UNITED STATES PATENT AND TRADEMARK OFFICE

APPLICATION NO.	FILING DATE	FIRST NAMED INVENTOR	ATTORNEY DOCKET NO.	CONFIRMATION NO.
10/044,368	01/10/2002	Thomas E. Broome	1001.1388101	8240
28/075 7590 04/22/2010 CROMPTON, SEAGER & TUFTE, LLC 1221 NICOLLET AVENUE SUITE 800 MINNEAPOLIS, MN 55403-2420				
EXAMINER				
ERIZO, DARWIN P				
ART UNIT		PAPER NUMBER		
3773				
MAIL DATE		DELIVERY MODE		
04/22/2010		PAPER

Office Action Summary

DETAILED ACTION

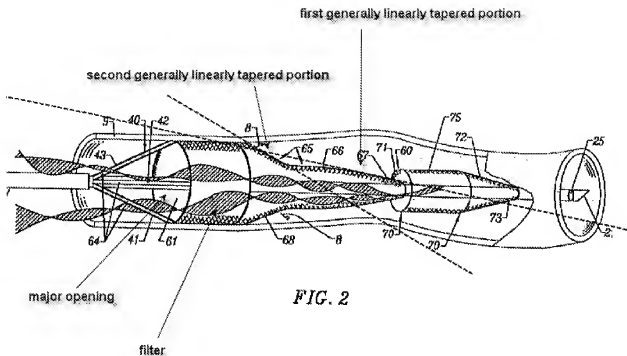
(claims 52, 72 and 92) Stanford discloses a filter assembly comprising an elongate shaft **20**, a filter disposed and attached to a distal end of the shaft (see attached Fig. 2 below, or even in Fig. 15), the filter including a filtering region (the open portion) and an attachment region; wherein the filtering region includes a major opening

defined adjacent the proximal end (see figure below) and is comprised of only a single layer of filter membrane that defines a filter basket and extending between the major opening and the distal end of the filtering region, the filtering region comprising apertures to allow the passage of blood through the filtering region; the filter membrane further comprising a first "generally linearly" tapered portion defining a first angle that is lesser (or different) than a second angle defined by a second "generally linearly" tapered portion (see figure below); wherein the filter has an expanded (Fig. 2) and contracted shape (Fig. 3); wherein the first tapered portion extends at the first included angle for a "substantial length" of the first tapered portion and the second tapered portion extends at the second included angle for a "substantial length" of the second tapered portion.

(claim 90) The second tapered portion extends proximally from the proximal end of the first tapered portion (see figure above).
